### STAFF RECOMMENDATION 929 Montrose Avenue February 20, 2019

**Application:** New Construction—Addition; Demolition—Partial  
**District:** Waverly-Belmont Neighborhood Conservation Zoning Overlay  
**Council District:** 07  
**Base Zoning:** R8  
**Map and Parcel Number:** 11801030900  
**Applicant:** Martin Wieck, Nine12 Architects  
**Project Lead:** Melissa Baldock, melissa.baldock@nashville.gov

**Description of Project:** Application is to reconfigure the roof on parts of the existing house and to construct a rear addition that is two feet (2') taller than the historic house.

Figure 1. 929 Montrose Avenue

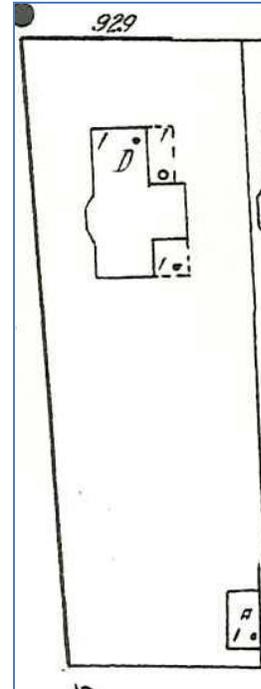
**Background:** 929 Montrose Avenue is a pre-1908 folk Victorian house that contributes to the historic character of the Waverly-Belmont Neighborhood Conservation Zoning Overlay (Figure 1). The house has been altered at the rear over the last century. Sometime between 1957 and 1968, the former porch at the rear was enclosed and extended wider than the house (Figures 2, 3, 4, and 5).

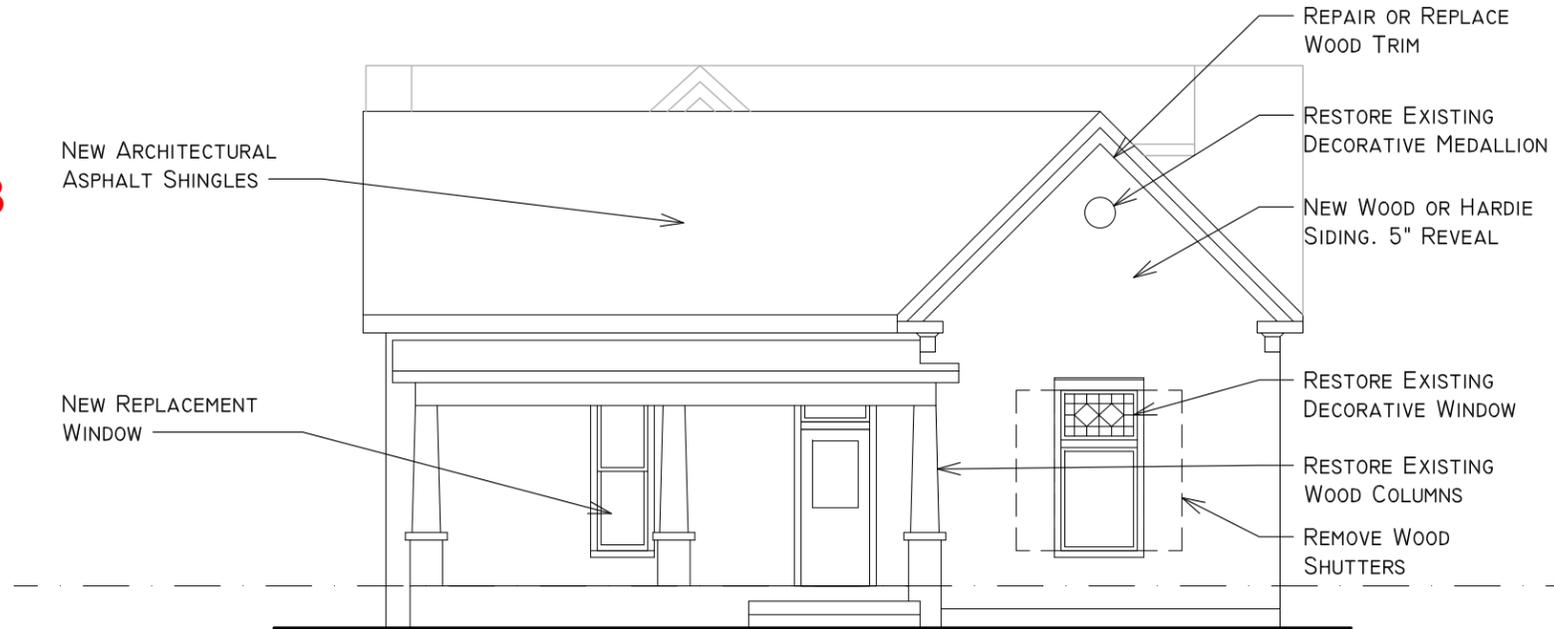
**Appurtenances & Utilities:** As mentioned under orientation, the applicant will be adding a walkway from the front to the rear entry porch. The applicant will also add four uncovered parking spaces at the rear, off the alley. No other changes to the site's appurtenances were indicated on the drawings. The location of the HVACs and other utilities was not noted. Staff asks that the HVACs be located on the rear façade, or on a side façade beyond the midpoint of the house in order to meet Section III.I. of the design guidelines.

Attachment A  
 1005 Paris Avenue  
 Approved by MHZC September 2018  
 HCP 2018056881

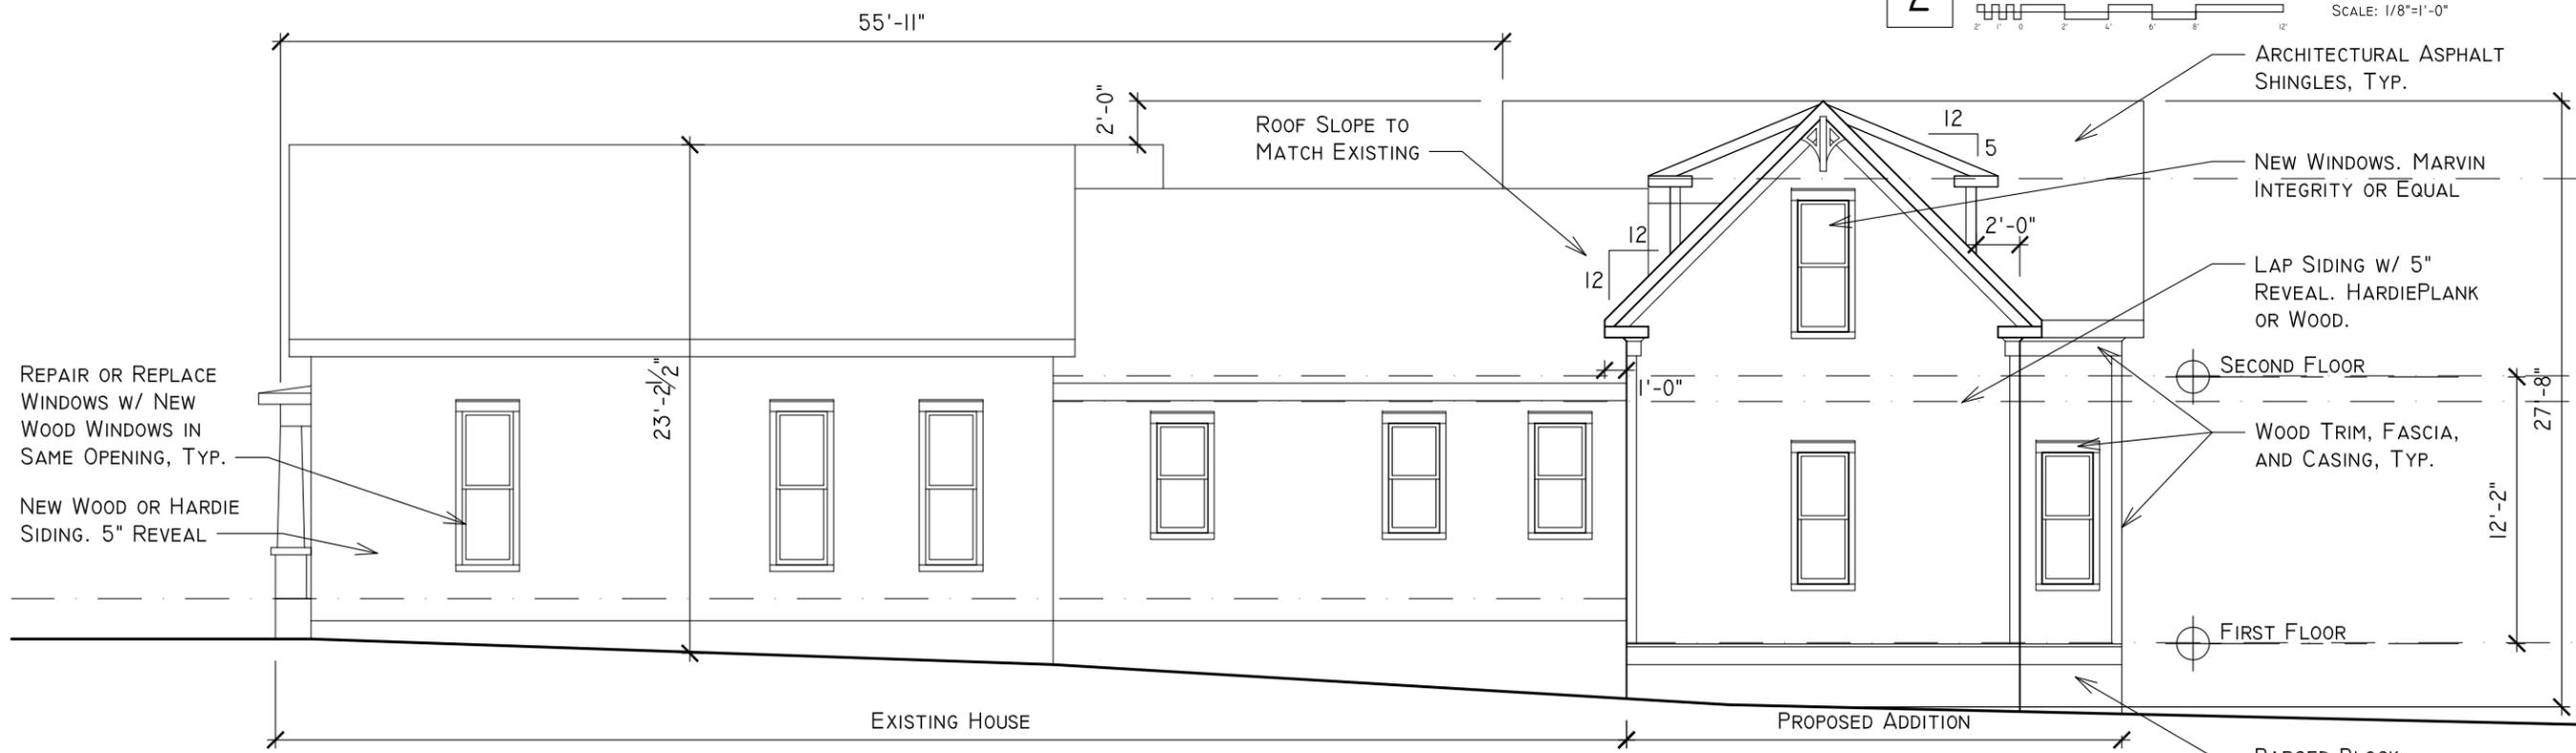
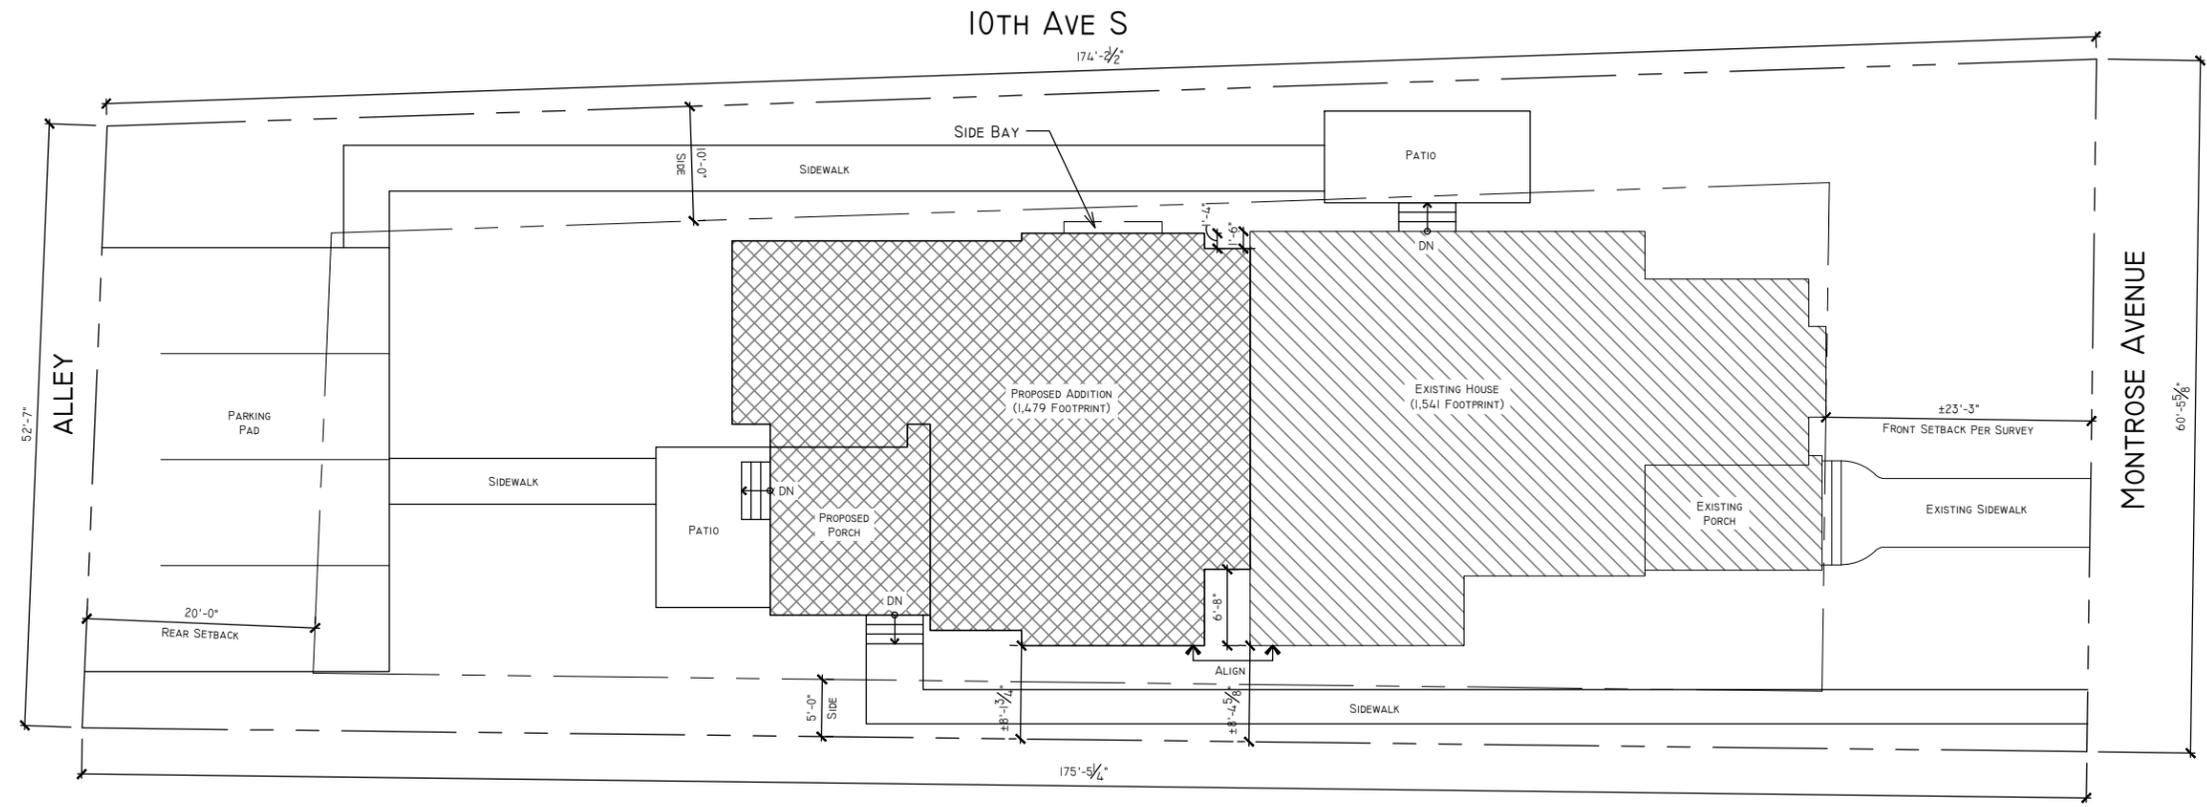
The applicant is proposing a two-story addition behind a one-story house. Because the lot slopes down towards the back of the lot, the applicant is able to step the floor line of the addition down so that the addition's ridge and eave heights are just two feet (2') taller than the historic house. Staff finds that this could be appropriate if the addition were inset appropriately. On the right/10th Avenue South elevation, the addition insets one foot, six inches (1'6") at the back corner of the house for a depth of four feet (4'), when it steps back out to line up with the main right side wall of the historic house. The two-story portion of the addition begins after the addition steps back out to line up with the main wall of the house. Since the addition's eave and ridge height are two feet (2') taller than those of the historic house, staff finds that the taller portion of the addition should be inset a minimum of two feet (2') on this side. This will help keep the larger scale of the two-story addition from overwhelming the one-story historic house. Staff recommends that the two story portion of the house be inset a minimum of two feet (2') from the line of the historic house, on the right side. The applicant has submitted as part of this application elevation drawings of 1005 Paris Avenue, which the Commission approved in September 2018. That elevation drawing is Attachment A.

SITE PLAN

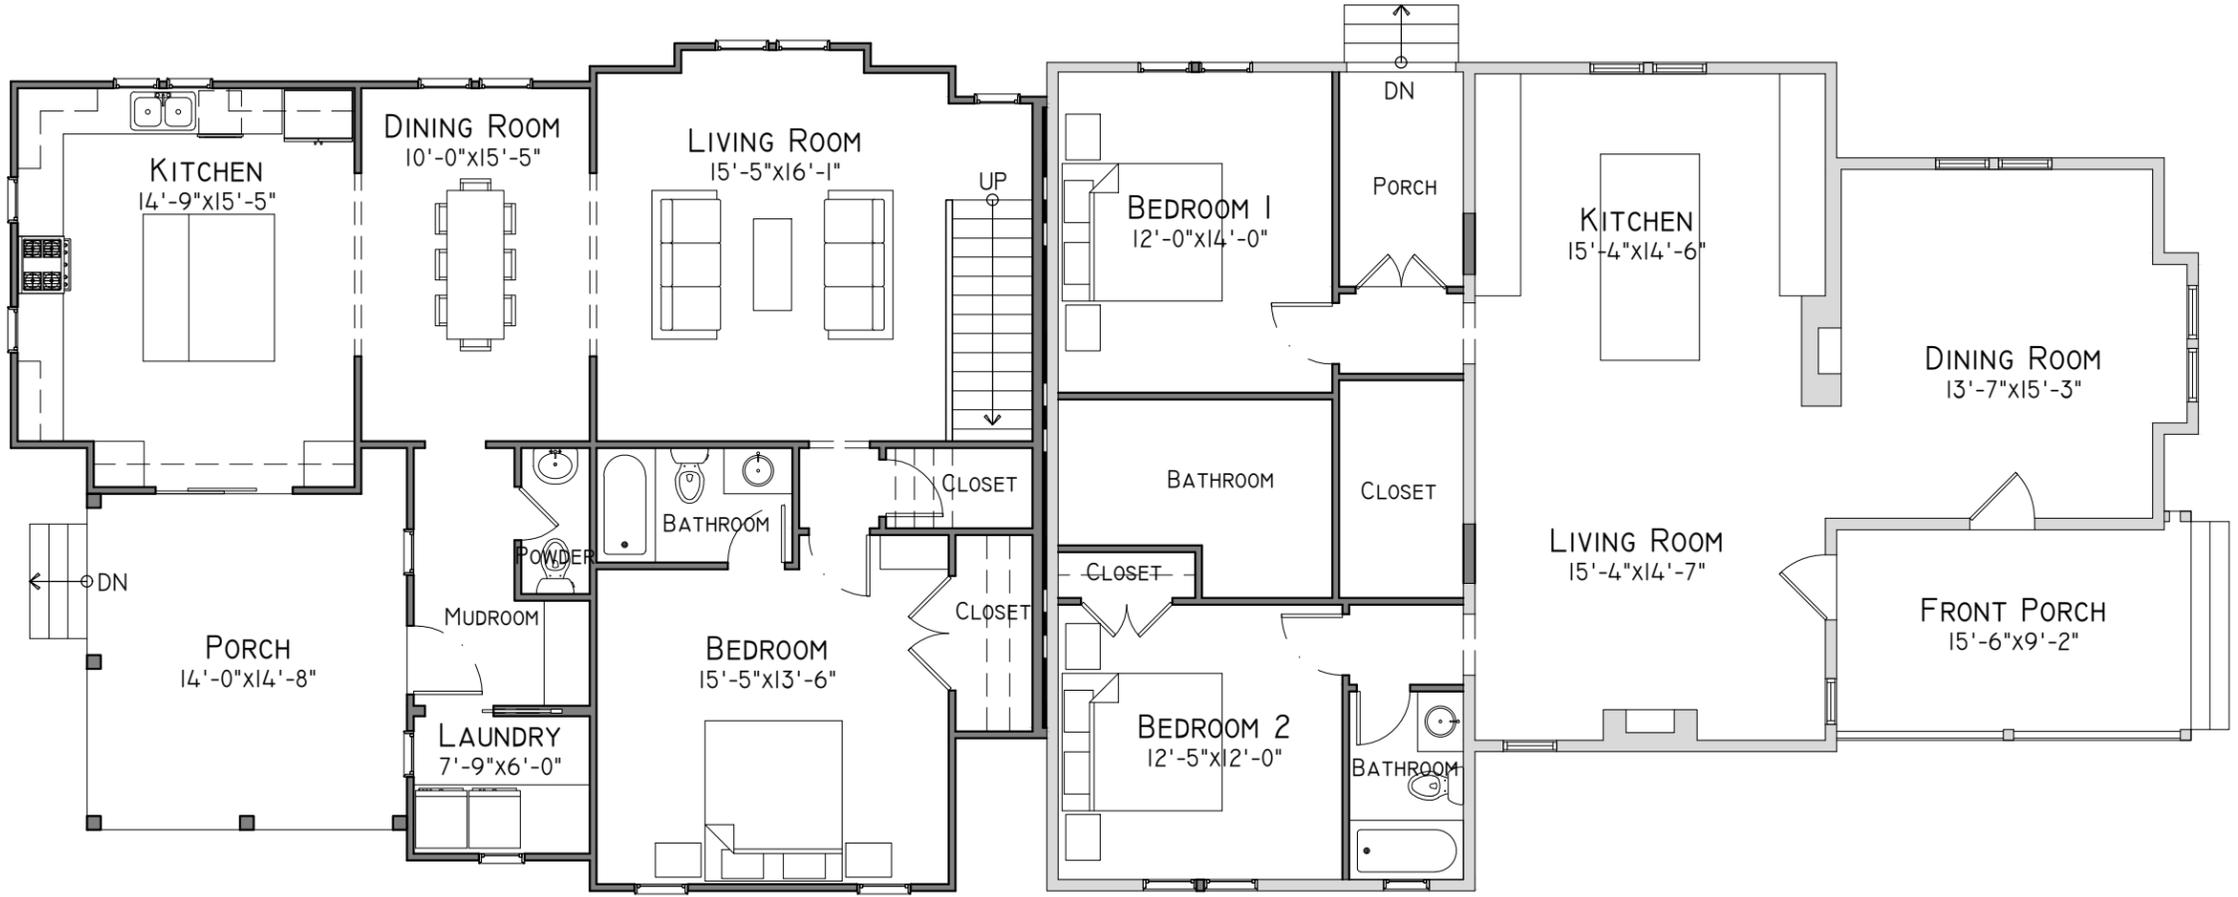
Setback & Rhythm of Spacing: The proposed addition meets all base zoning setbacks. It will be a minimum of eleven feet (11') from the right/10<sup>th</sup> Avenue South side property line and over eight feet (8') from the left side property line. It will be over fifty-feet (50') from the rear property line. The addition will not alter the rhythm of spacing of houses along Montrose Avenue. Staff finds that the addition's setbacks and rhythm of spacing meet Sections III.C. and IV. of the design guidelines.

Vehicular access to the site will be via the rear alley, which meets the design guidelines. The site plan shows four uncovered parking spaces off of the alley. The existing front walkway will remain, and the applicant intends to add a secondary walkway to the rear entry from the sidewalk on Montrose Avenue.

EXTERIOR ELEVATIONS  
04

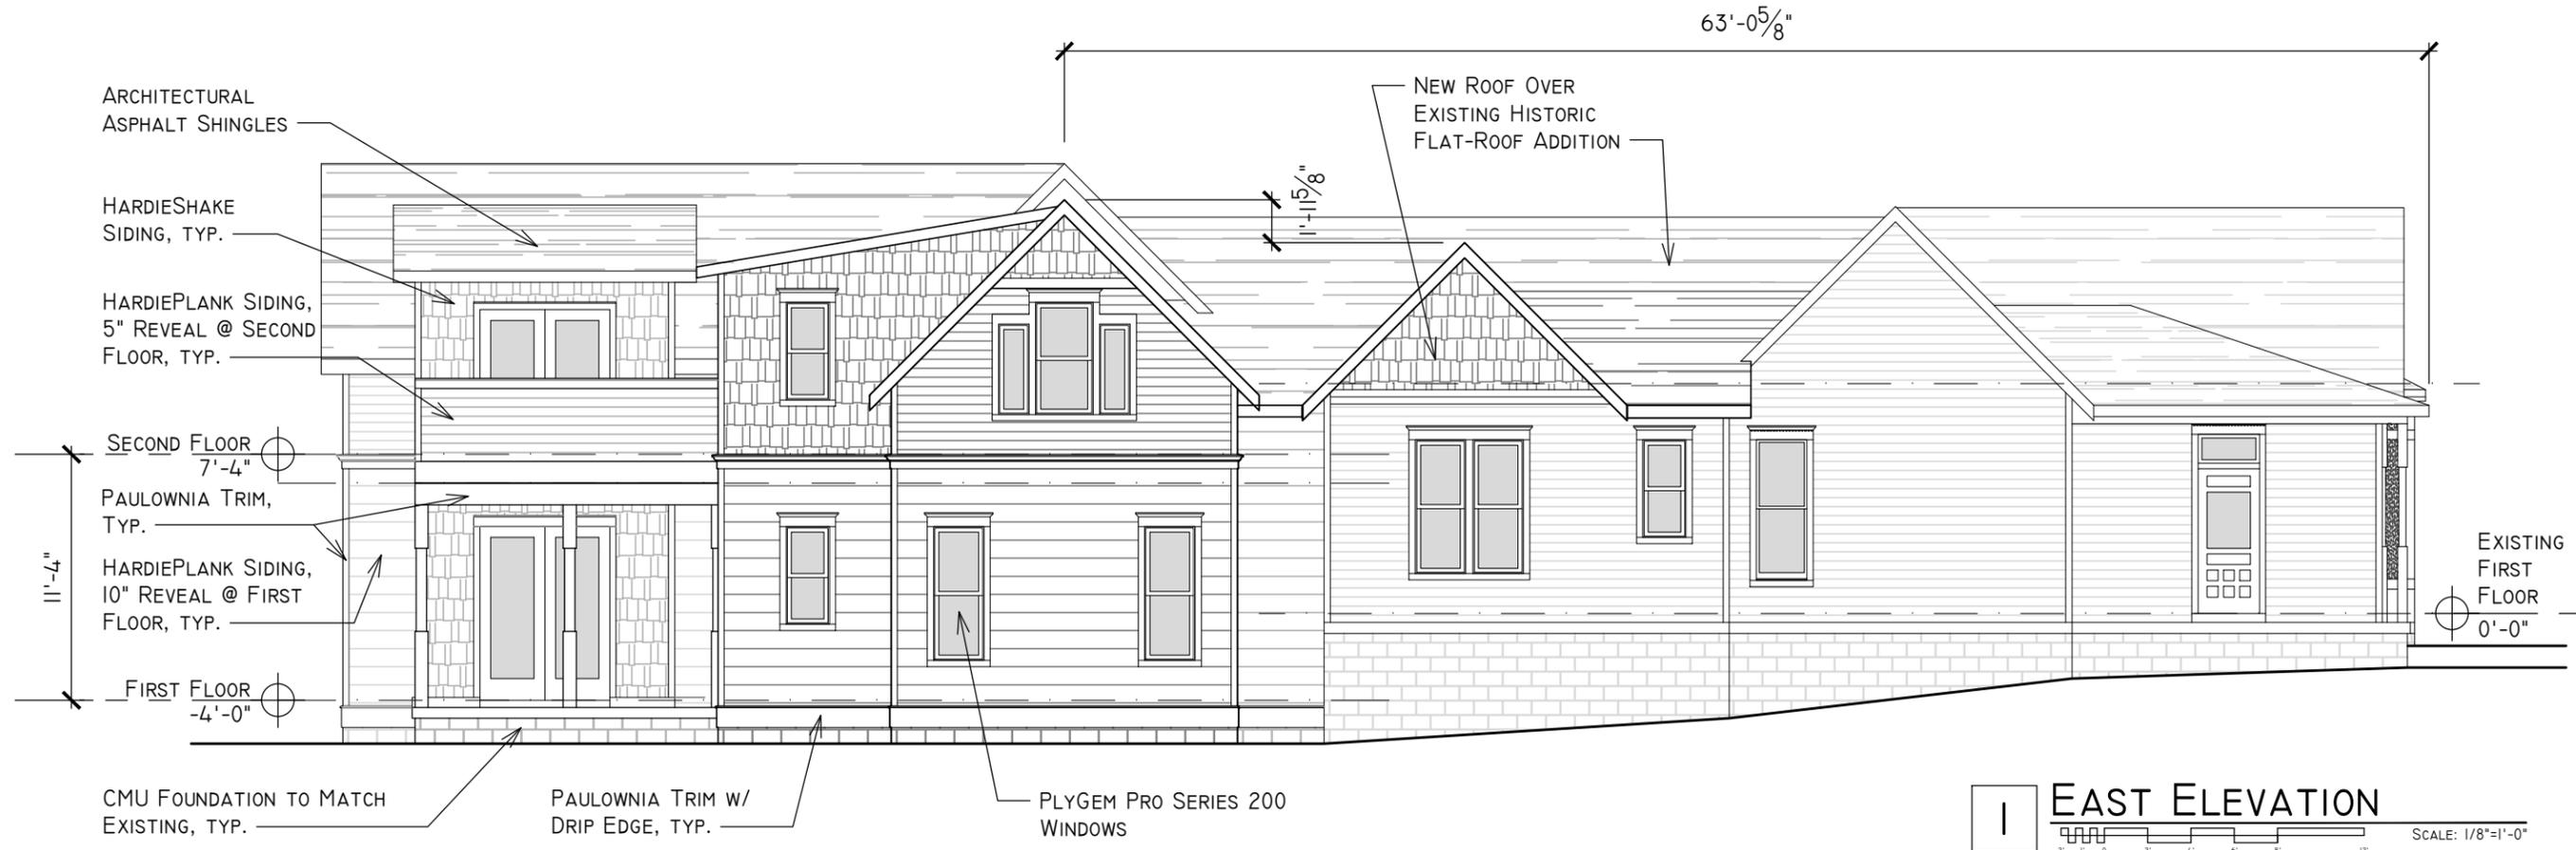
On the right façade, the applicant has incorporated a one-story bay that is just one foot (1') deep. This bay will therefore be one foot (1') wider than the historic house. Staff finds this to be appropriate because the bay is just one foot (1') deep and nine feet (9') long, and it is a true one story bay in the same size and scale as the historic bay on the front porch. In addition, this lot is wider than typical lots in the neighborhood at over sixty feet (60'), making a wider addition appropriate, and the side bay meets the base zoning setback of ten feet (10').

On the left elevation, the new addition steps in close to seven feet (7') from the existing non-historic side addition; this new part of the addition is inset one foot (1') from the line of the historic left side wall of the house. After a depth of four feet (4'), the addition steps back out to line up with the wall of the existing addition. This part of the addition will have a side-oriented gable in line with the existing addition and extending two feet (2') taller. Staff finds this to be appropriate since the existing side addition is not historic and this part of the new addition is no taller than the original side-oriented gable on the historic house.

The addition's roof form is a mixture of gables and shed roof forms. Their slopes largely match the slopes of the historic house's gables. The taller part of the addition is gabled, meeting the design guidelines. Nevertheless, staff recommends that the taller part of the addition be inset two feet (2') from the main side walls of the house on the right side. With this condition, staff finds that the proposed roof forms meet Sections III.E. and IV. of the design guidelines.

With the condition that the taller portion of the addition be inset two feet (2') from the main wall of the house on the right side, staff finds that the addition's height and scale meet Sections III.A., III.B., and IV. of the design guidelines.

1. The taller portion of the addition be inset two feet (2') from the main side wall of the house on the right/10th Avenue South elevation;
2. Staff approve the final details, dimensions and materials of windows and doors prior to purchase and installation;
3. Staff approve the roof shingle color;
4. Staff approve the porch floor and step materials for the side and rear porches;
5. The primary exterior cladding on the addition shall have a maximum reveal of five inches (5"); and
6. The HVAC be located behind the house or on either side, beyond the mid-point of the house.
